foundation investigation and design report

WP 49-71-01 DIST 6
HWY 427 STR SITE 37-1085
Finch Avenue over Humber River
(West Branch)

Re: Finch Avenue over West Humber Bridge
Municipal Structure Review

RE: Proposed Diversion of Humber River (West Branch)
Near Future Finch Ave. Crossing, Site 37-1085,
W.P. 49-71-01, District 6

CHANNEL X-SECTION NEAR FINCH AVE.

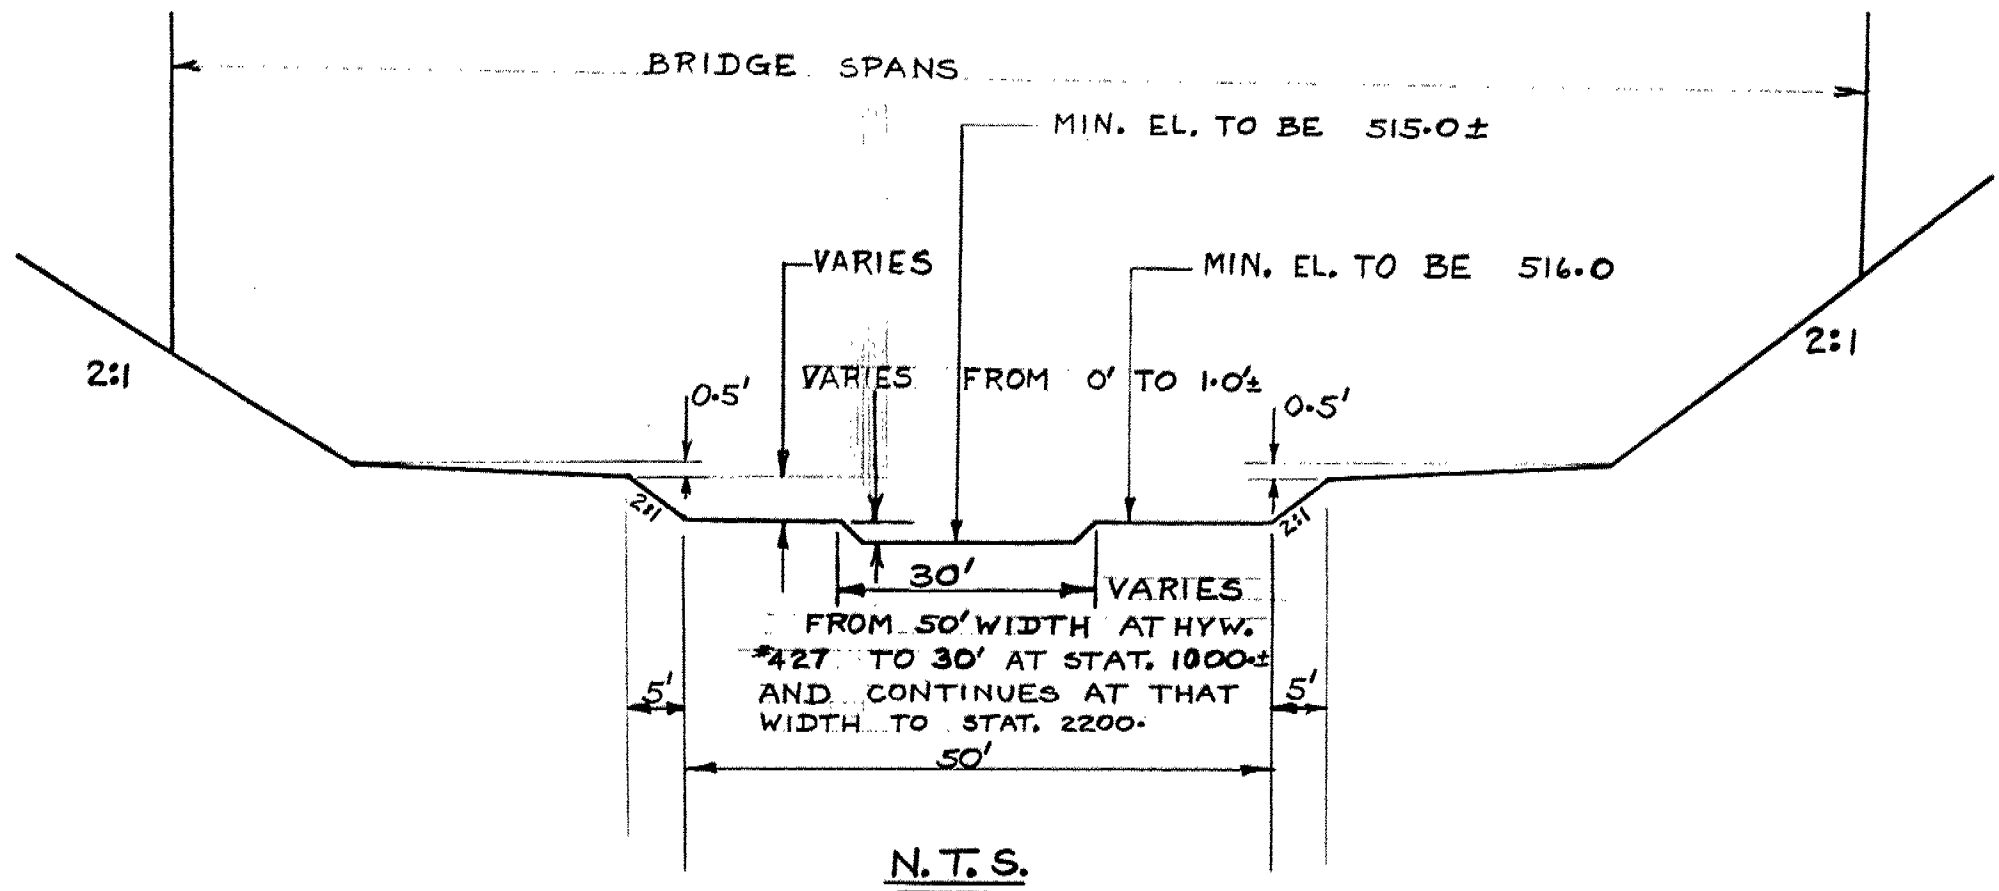
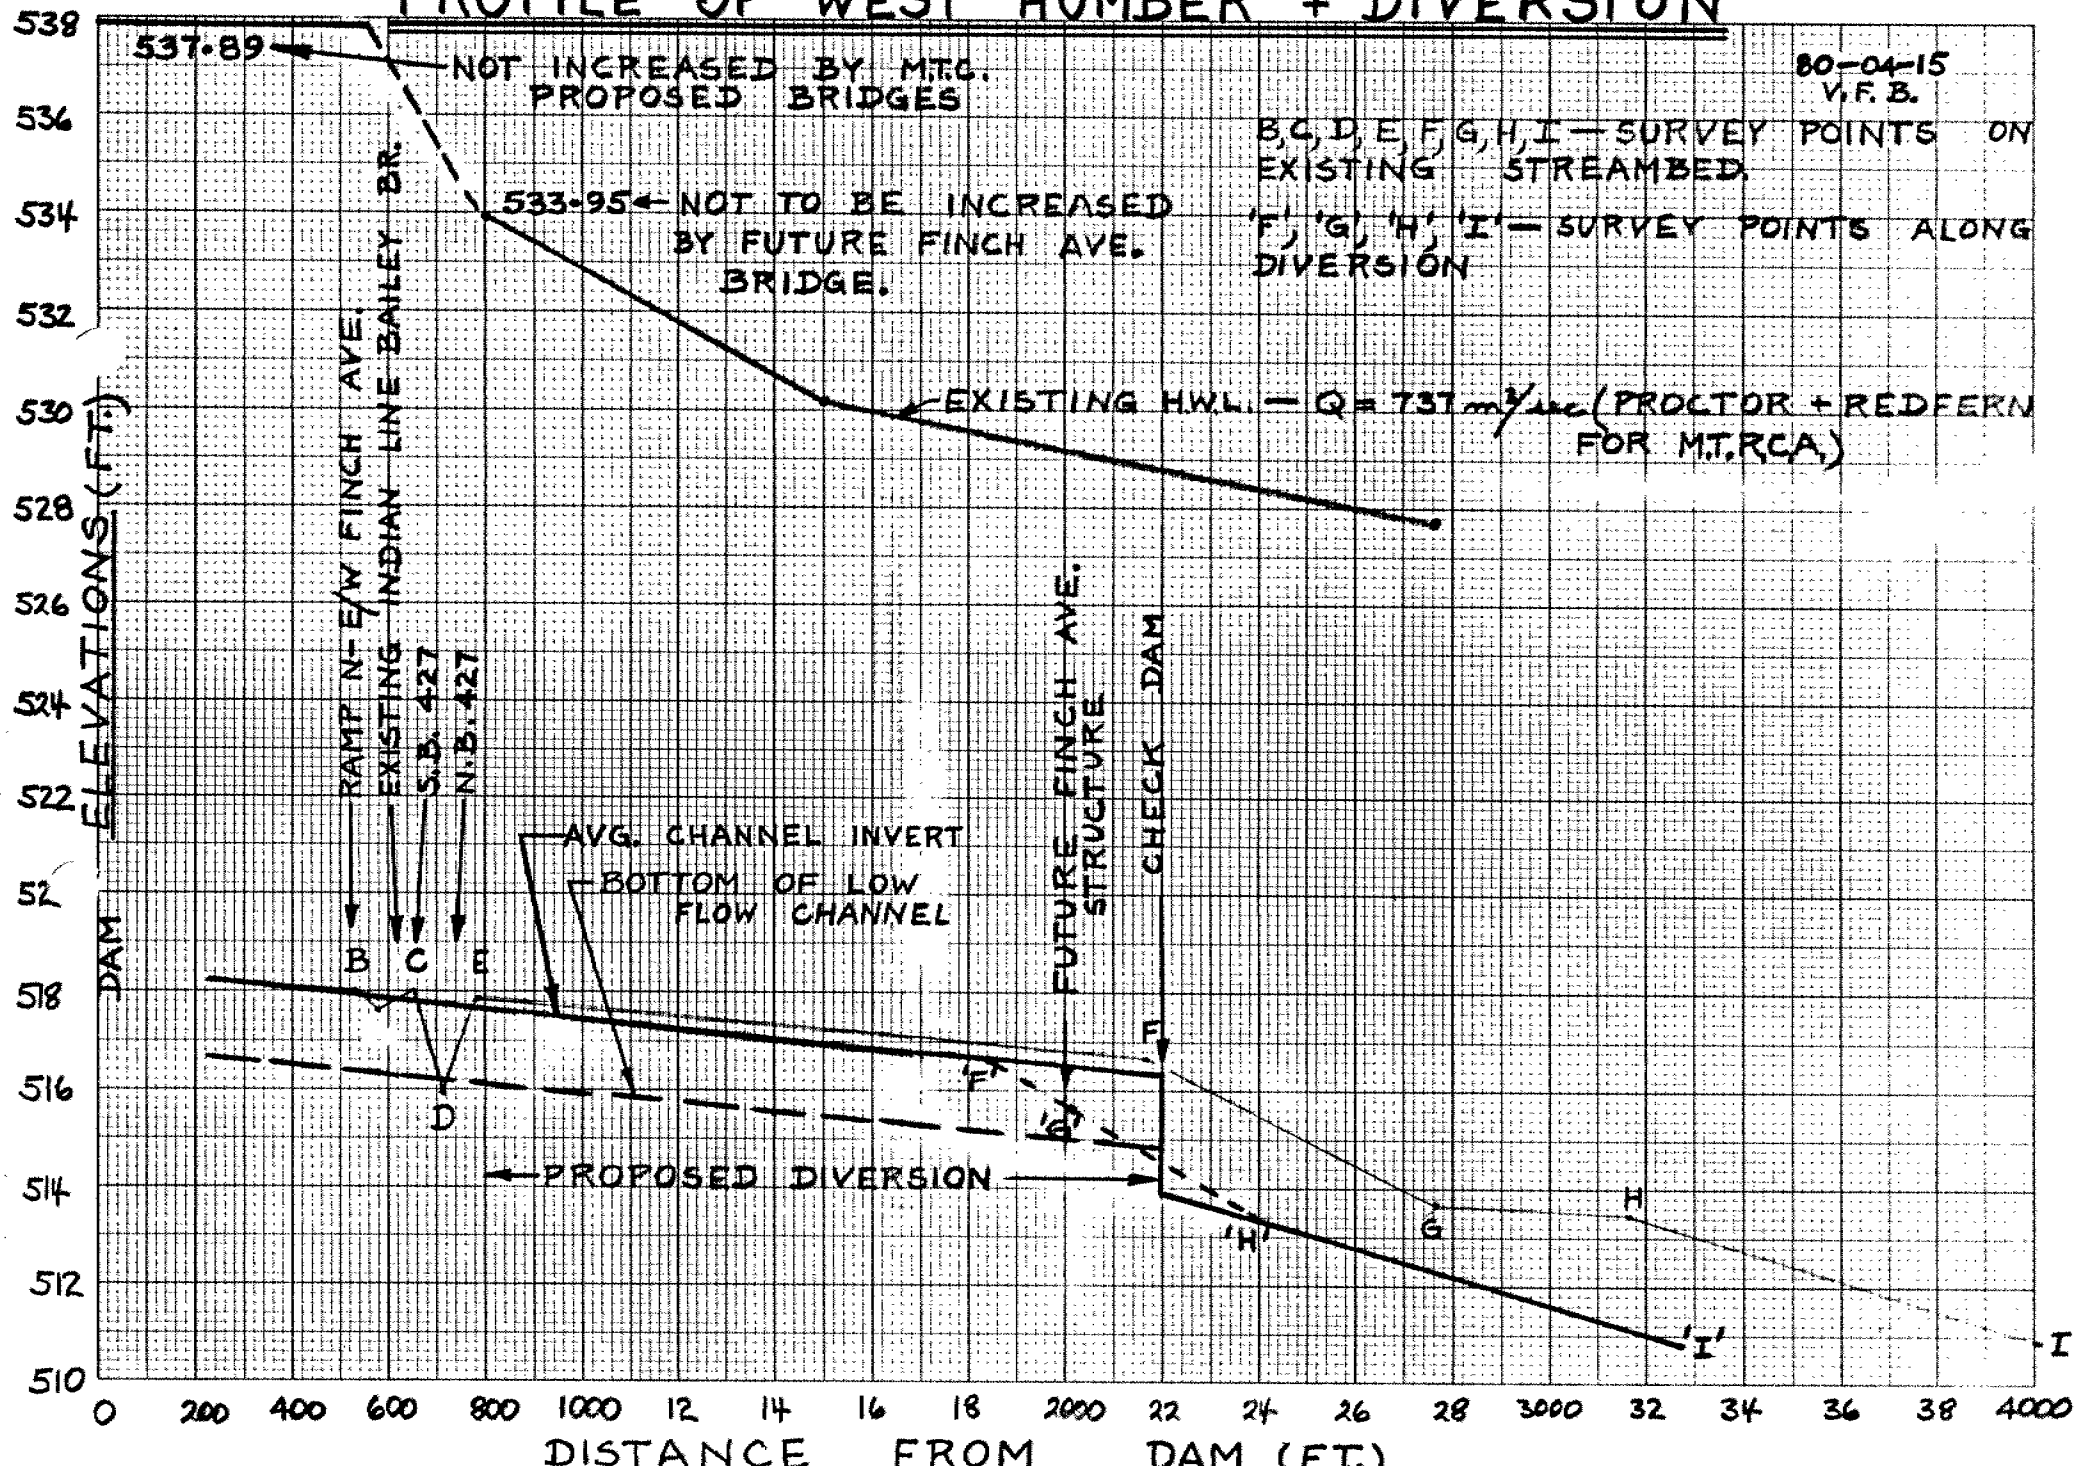
We would like to take reference to our earlier memo of 80-03-26 in regard to the adverse effects of the artesian conditions on the proposed channel invert. The profile of the West Humber Diversion channel (as per our Hydrology Report BW5023) puts the average channel invert at el. 516.5, assuming a check dam downstream of Finch Avenue. Therefore, the minimum channel invert would be at el. 515. which was indicated as being too low by the Foundations Office. This was based on the local artesian conditions with a 50'+ wide low flow channel used in their calculations.

New calculations by the Foundations Office show that they would tolerate a low flow channel width of 30 ft. with invert down to el. 515.+ .

As a result, we propose to vary the width of the bottom portion of the low flow channel (that, which is below el. 516.+) from 50' at the Highway 427 bridges to 30' width downstream of station 1000. The taper will be smooth and gradual. This channel width will be continued at the 30' width further downstream through the proposed bridge site to approximately 200' downstream of Finch Avenue. A short 25' transition section is required here where the diversion meets the existing channel.

Similar as in our earlier memo, the low flow channel should be protected with filter cloth and 4" to 6"Ø stone. The 4"-6"Ø stone may also be placed in the 30' wide low flow channel beneath the future structure.
